Emergency Management

Town of Fairhaven ADA Transition Plan

November 2024

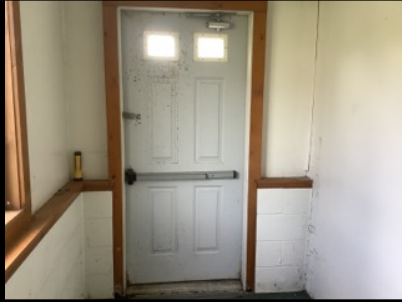
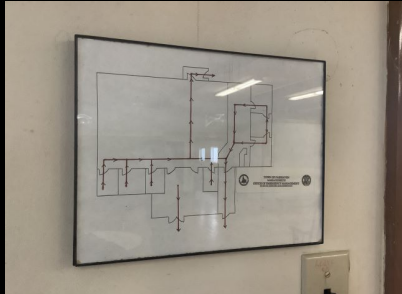
Entrance												
4	Inaccessible South Entrance	Ext.		Entrance	Other		Directional sign to accessible entrance not provided	-	Provide a directional sign indicating the location of the nearest accessible entrance.	1	450	\$450

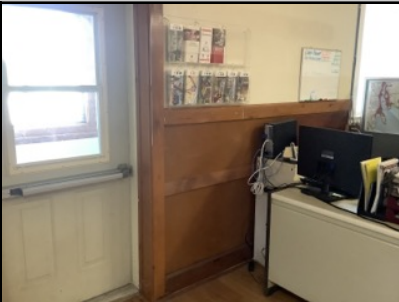
ID	Location	Floor	Room	Element	Type	Photo	Issues	Current Measure	Recommendations	Quantity	Price	Cost Estimation
10	Kitchen	1		Means of Egress	N/A		Tactile exit sign not provided Directional sign to accessible emergency exit not provided	- -	Ensure that a tactile exit sign with raised characters and braille is provided at the exit door. Mount the sign between 48" - 60" above the finished floor located on the latch side of the door. Provide a directional sign indicating the location of the nearest accessible emergency exit.	1	250 250	\$500
											500	
11	Kitchen	1		Means of Egress	N/A		Tactile exit sign not provided Directional sign to accessible emergency exit not provided	- -	Ensure that a tactile exit sign with raised characters and braille is provided at the exit door. Mount the sign between 48" - 60" above the finished floor located on the latch side of the door. Provide a directional sign indicating the location of the nearest accessible emergency exit.	1	250 250	\$500
